Government of India
Ministry of Environment, Forest and Climate Change
IA Division
(Thermal Projects)

Minutes of AGENDA FOR 11TH MEETING OF THE EXPERT APPRAISAL COMMITTEE (EAC) (THERMAL POWER PROJECTS) TO BE HELD ON 27TH – 28TH JUNE, 2024 meeting Thermal Projects held from 27/06/2024 to 28/06/2024 **Date:** 16/07/2024

Sipat Super Thermal Power Project Stage-III (1x800 MW) by NTPC LIMITED located at BILASPUR, CHHATTISGARH			
Proposal For		Fresh EC	
Proposal No	File No	Submission Date	Activity

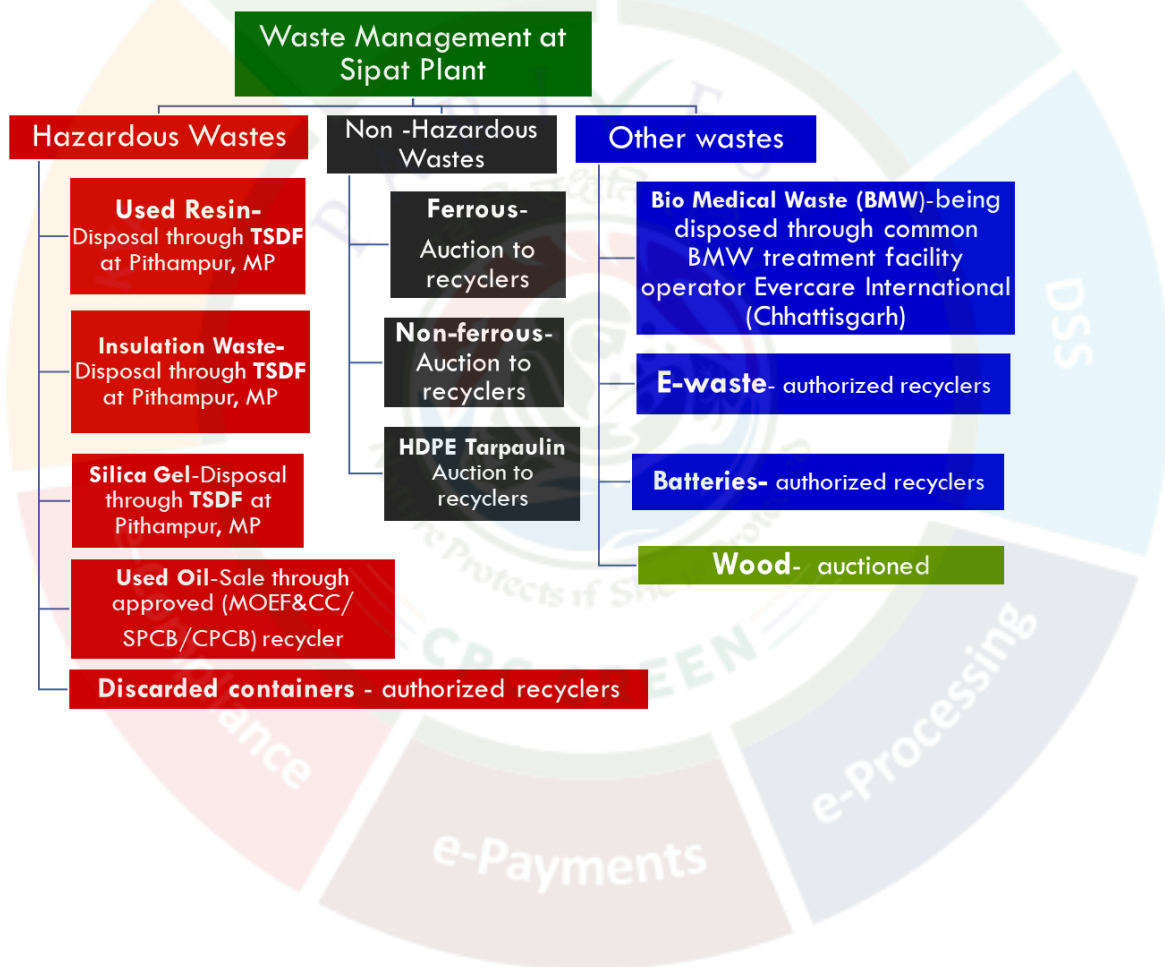
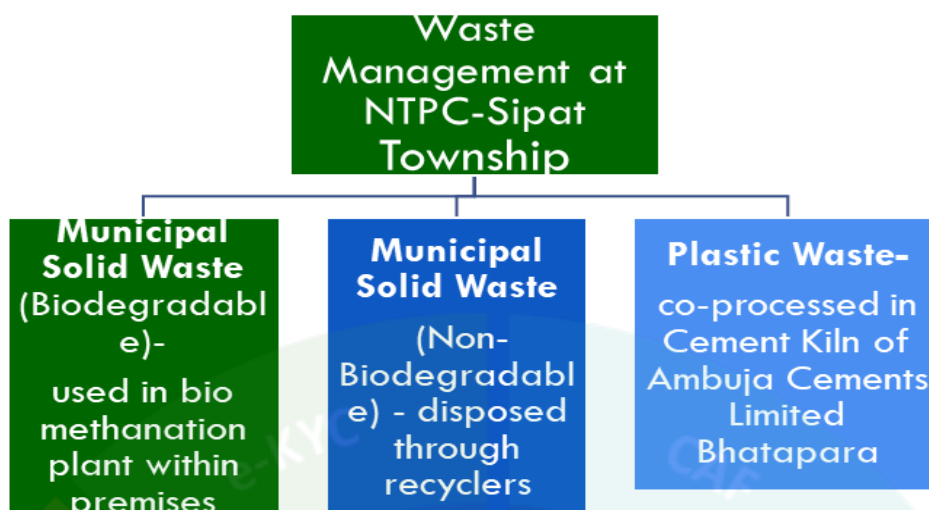
Query 9: A survey of E-vehicles and battery-operated vehicles shall be carried out within the plant area and an action plan with a timeline for switching over to renewable sources shall be submitted.

Reply: E-Vehicles: Presently in NTPC Sipat STPP

- All 7 nos. materials shifting vehicles are Battery operated.

- Three (3) nos. Forklift are battery operated and
- Two (2) nos. E-rickshaws are operational.
- There are 9 nos. Diesel operated Forklifts which are of higher capacity. These vehicles will be switched over to E-Vehicle as per availability in market.
- Also, there is plan to replace the passenger vehicles to E-vehicle as per market availability and infrastructure in phased manner.
